STATE OF NORTH CAROLINA
DEPARTMENT OF TRANSPORTATION

Subject: Request for Modification of the Phased Section 404 Individual Permit and Section 401 Individual Water Quality Certification, Neuse River Riparian Buffer Authorization for the construction of the Triangle Expressway Southeast Extension from NC-55 Bypass in Apex to I-40, Wake and Johnston Counties. TIP Nos. R-2721, R-2828, and R-2829. Debit \$570 from WBS 376731.TA2.

This letter is a request to modification on four sites of the R-2828 section of the Complete 540 project. Sites 32, 48, 49, and a new site (Site 91) are being modified.

Figure
1

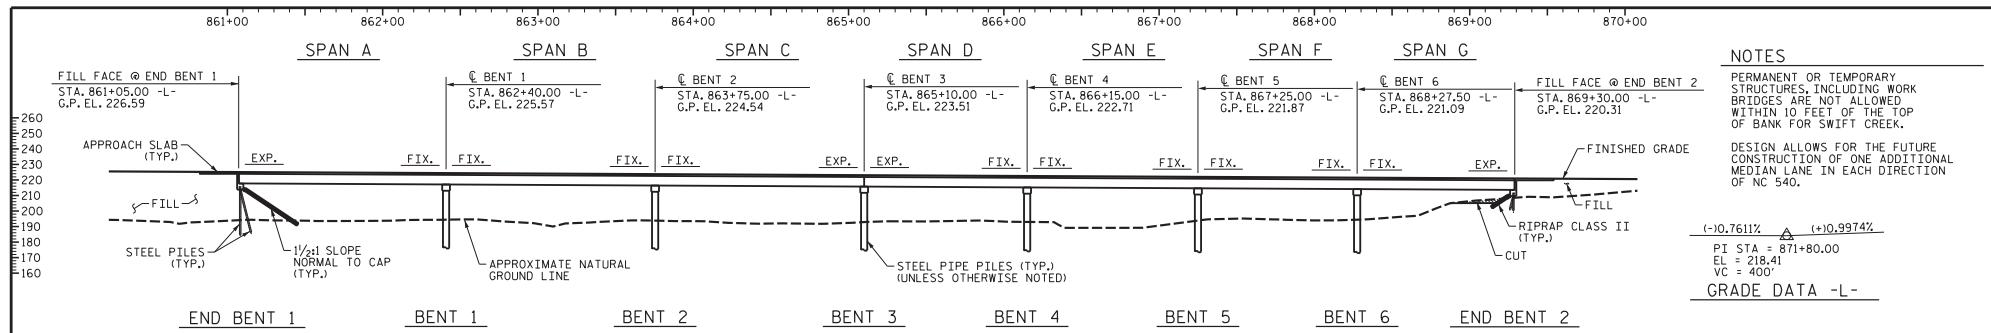
During the design stage, a haul road was planned that traveled parallel to the project along Gentle Rain Drive, which is a little used dead-end road. The haul road then cuts over to the project area. This haul road is critical to the project. It is not only much safer by avoiding areas of high traffic volumes, but significantly decreases the haul route, thereby reducing emissions and expediting project construction. The original placement of the haul road considered jurisdictional features, but unbeknownst to the planner the mapping used to choose the route showed streams and associated riparian buffers, but not the complete wetland boundary of Wetland WED. The boundary for WED was not completely shown as it had been “clipped” to the original project area boundary. Thus, it continued just outside the project right-of-way. As a result, it was not until LBJV was performing due diligence for the haul road in January 2021 that it was realized the proposed haul road placement was through a wetland, as shown in Figure 1.

Three Oaks personnel investigated the area to determine a route that would avoid and minimize impacts to Wetland WED and other jurisdictional features. After the field investigation, it was determined that Wetland WED could be avoided but Stream SDQ, which runs between Gentle Rain Drive and the project, could not be completely avoided. However, a section of the stream was identified where there had been a crossing at some point in the past. Utilizing this crossing would minimize impacts as the vegetation here was noticeably younger, the stream was straighter, and the area had already been graded to a gentler slope. Based on this information, the haul road has been revised to cross at this area. The haul road width has been reduced to 40' at the stream crossing and associated riparian buffers, which is the minimum needed to accommodate a single off-road scraper. This crossing will result in

- Permit Site 91 (Permit Drawing 132 and 133 of 171, Plan Sheet 37)
 - Temporary crossing of Stream SDQ due to haul road

- 66 linear feet (LF) of Temporary Stream Impacts
- Permit Site 91 (Buffer Drawing 25 of 42, Plan Sheet 37)
 - Temporary crossing of Stream SDQ due to haul road
 - Increase of 4,000 Sq. Ft. of Zone 1 Buffer Impacts
 - Increase of 2,577 Sq. Ft. of Zone 2 Buffer Impacts

Attachment B

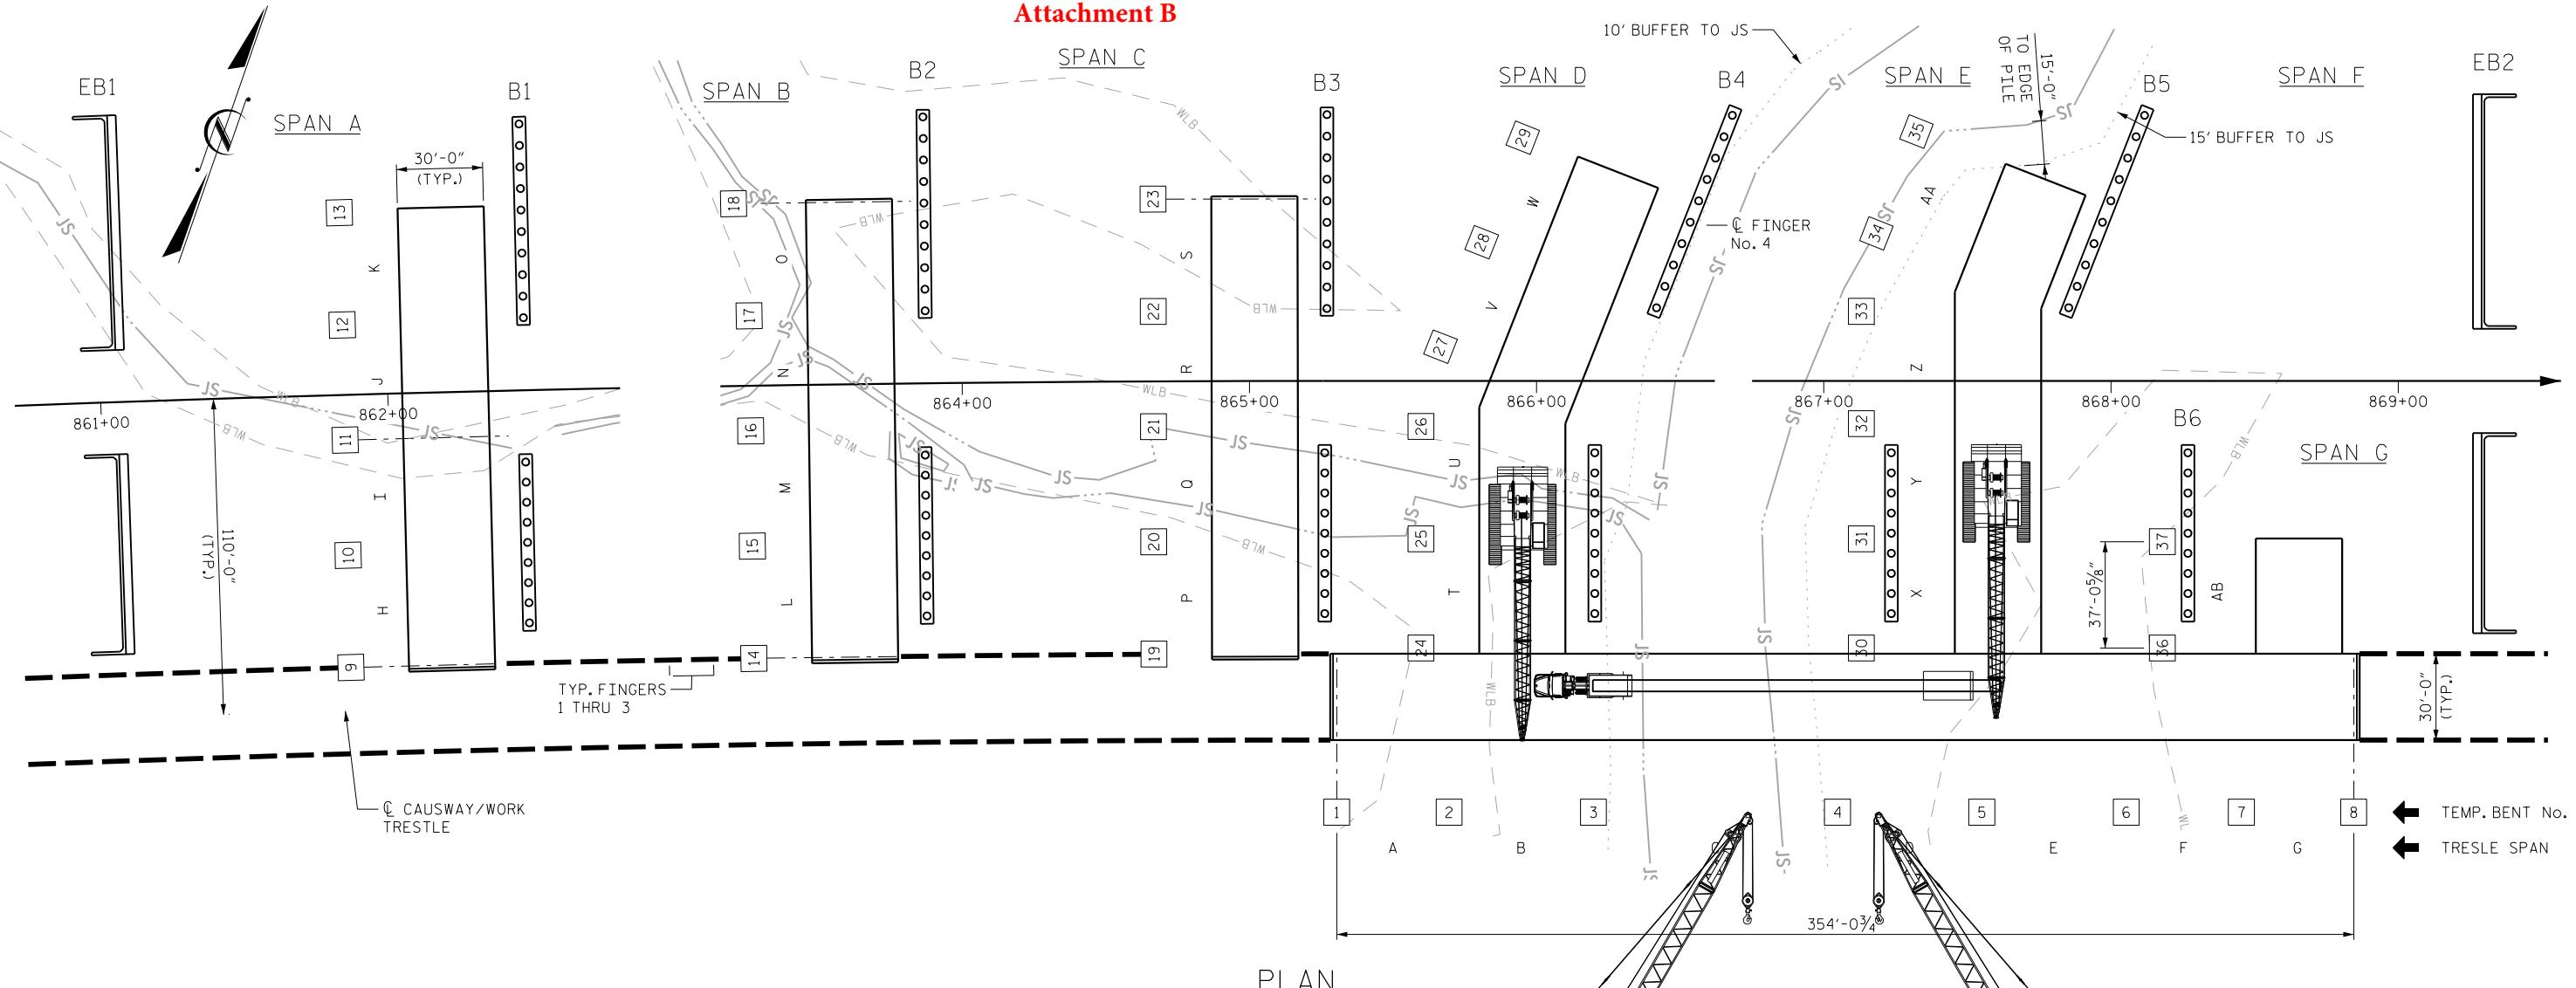
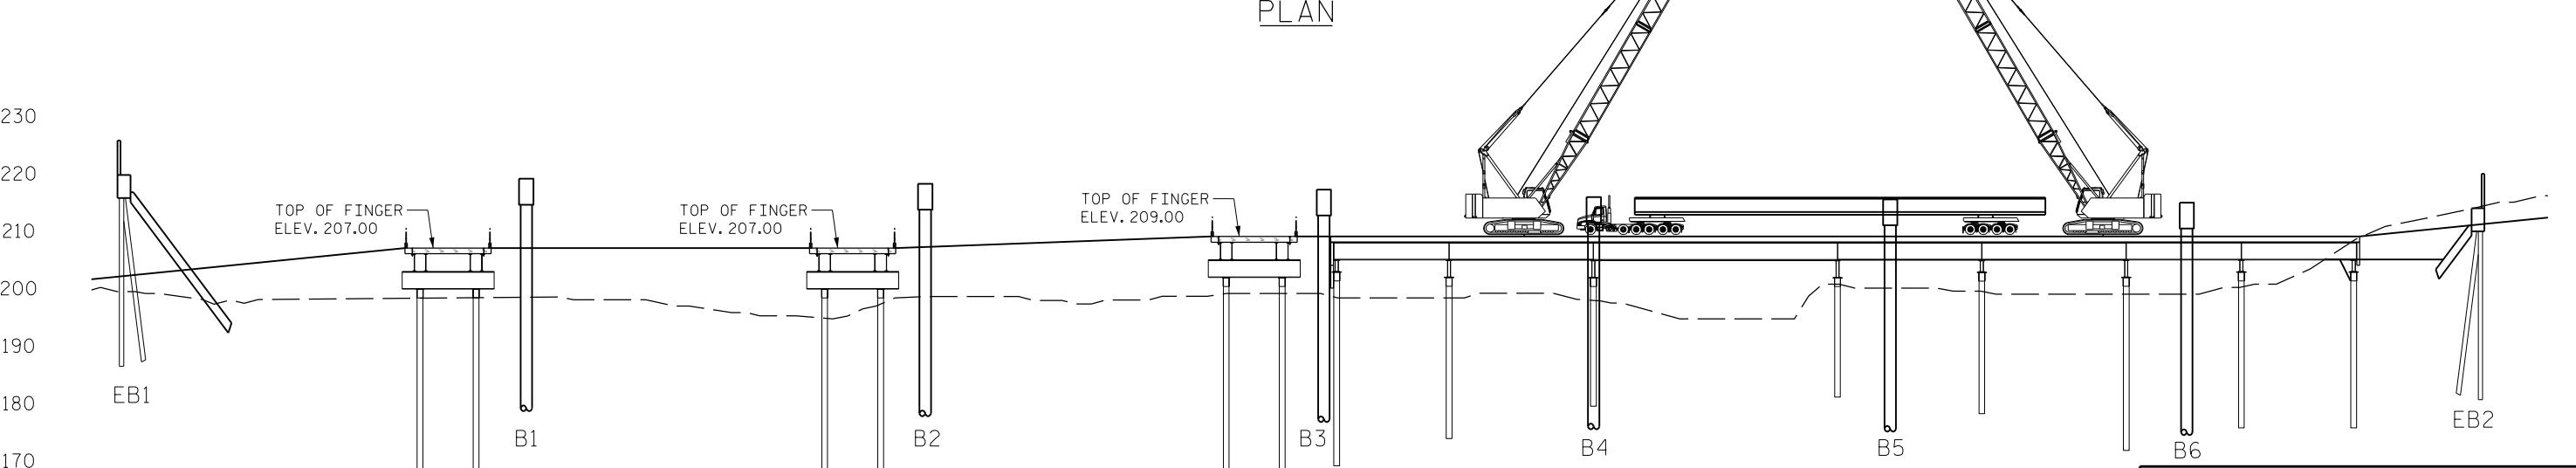
Since the 4C meeting and receiving the final permit drawings, Lane-Blythe Joint Venture (LBJV) enlisted a trestle designer to fully design the trestle to include girder erection/sequencing, crane placement during girder erections and to improve overall safety of operations utilizing the trestle. The original trestle plan placed the trestle on the south side of the two bridges west of Swift Creek and transitioned to between the bridges east of Swift Creek (Attachment A). This bend in the trestle posed significant concerns regarding the safe delivery and erection of the girders for the proposed bridge.

The new design removes the bend with a straight haul road which results in a safer delivery and erection of the bridge girders, a depiction of which is provided in Attachment B. The new haul road design is provided in revised Plan Sheet 29, but there is no change in jurisdictional impacts. All girder deliveries will be along this straightened portion of the trestle. This proposed design improves safety related to the delivery of other related bridge materials, that include formwork and reinforcing steel and removes any turning movements for concrete deliveries. This proposed design also eliminates permitted disturbance between the bridges east of Swift Creek.

- The trestle crossing is more perpendicular to Swift Creek.
- This placement decreased the required clear span width of Swift Creek from 110 feet to 85 feet; thus, minimizing the potential of any issues related to the spanning of Swift Creek.
- The trestle fingers were designed with an increased distance from top of existing bank from the required minimum 10 feet to edge of the trestle pile to a minimum of 15 feet. This distance will be field verified prior to placement of the trestle pile and can be adjusted, if needed, to accommodate this requirement.

- Permit Site 48 (Buffer Drawing 20 of 42, Plan Sheet 28)
 - Alteration of work trestle configuration:
 - Increase of 2,160 square feet (Sq. Ft.) of Zone 1 Buffer Impacts
 - Increase of 1,168 Sq. Ft. of Zone 2 Buffer Impacts
- Permit Site 48 (Permit Drawing 105 and 106 of 171, Plan Sheet 28)
 - Alteration of work trestle configuration:
 - Increase of 0.014 acre of Hand Clearing Impacts
- Permit Site 49 (Permit Drawing 105 and 106 of 171, Plan Sheet 28)
 - Alteration of work trestle configuration:
 - Increase of 0.06 acre of Hand Clearing Impacts

SITE #48 NOTES:
 1. PERMANENT FILL IMPACT FOR PERMANENT BENTS.
 2. ALL CLEARING, INCLUDING UPLANDS, UNDER BRIDGE
 WILL BE HAND CLEARING.

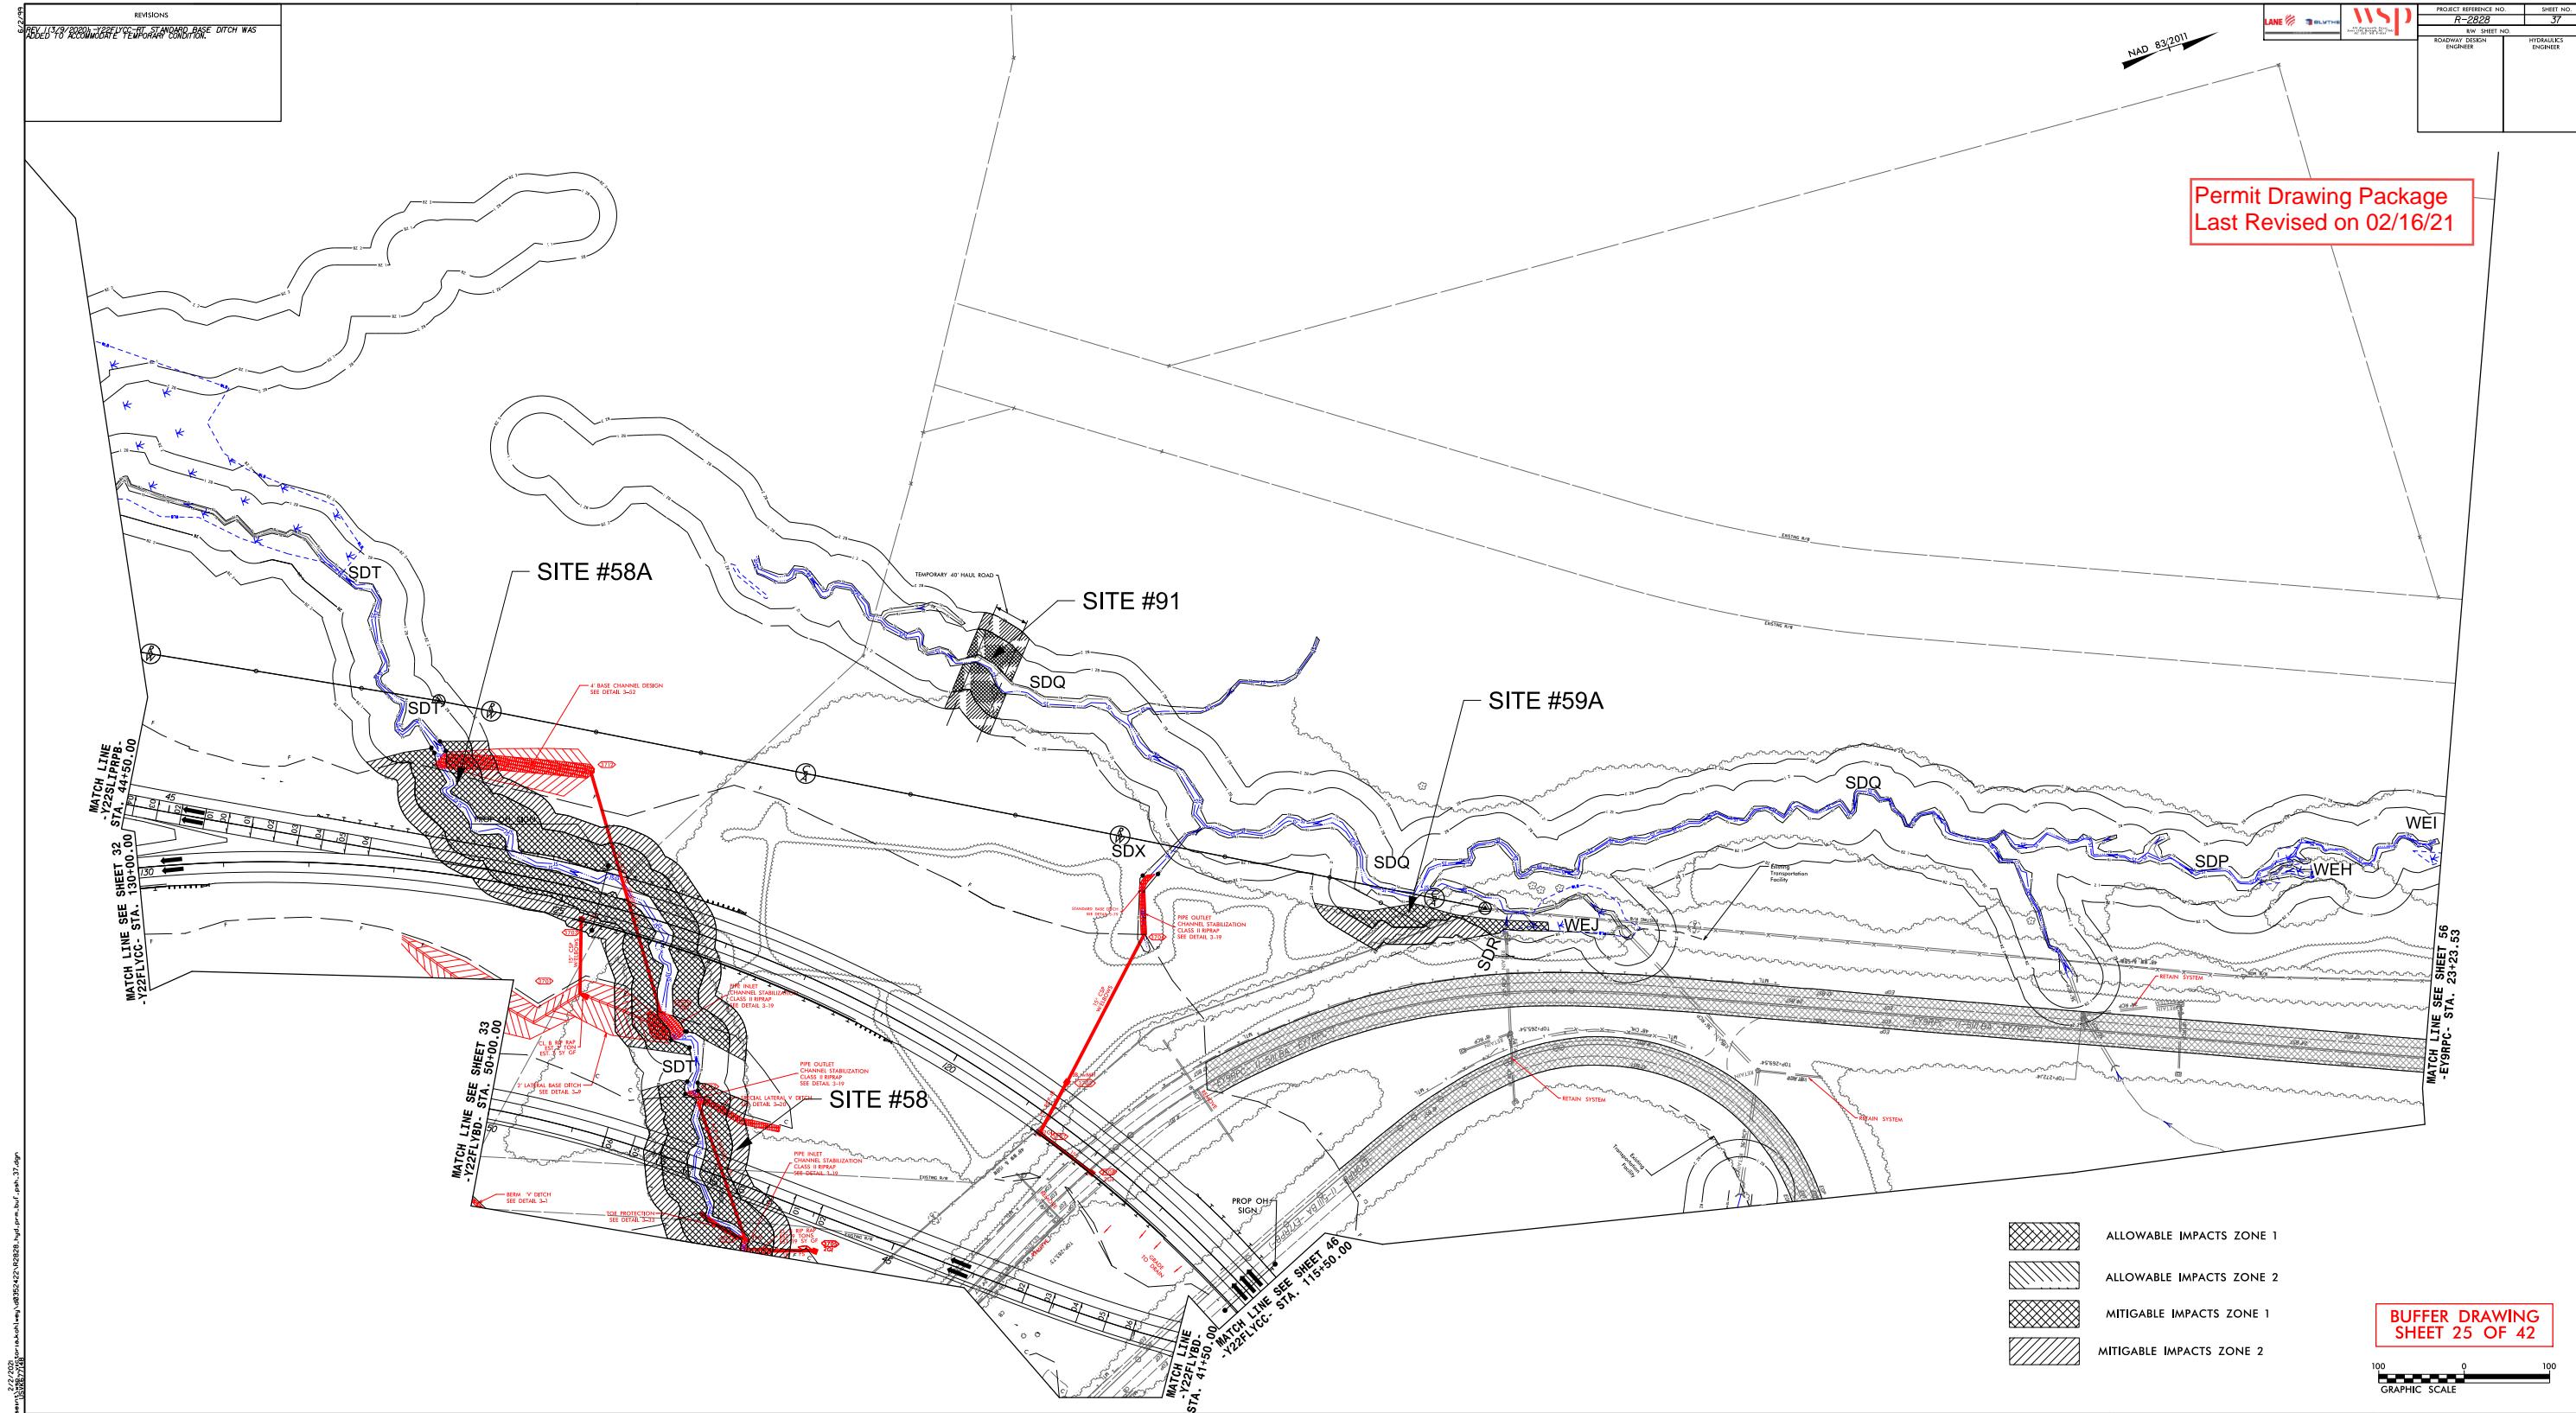
The new trestle design will result in the following changes in permitted impacts:
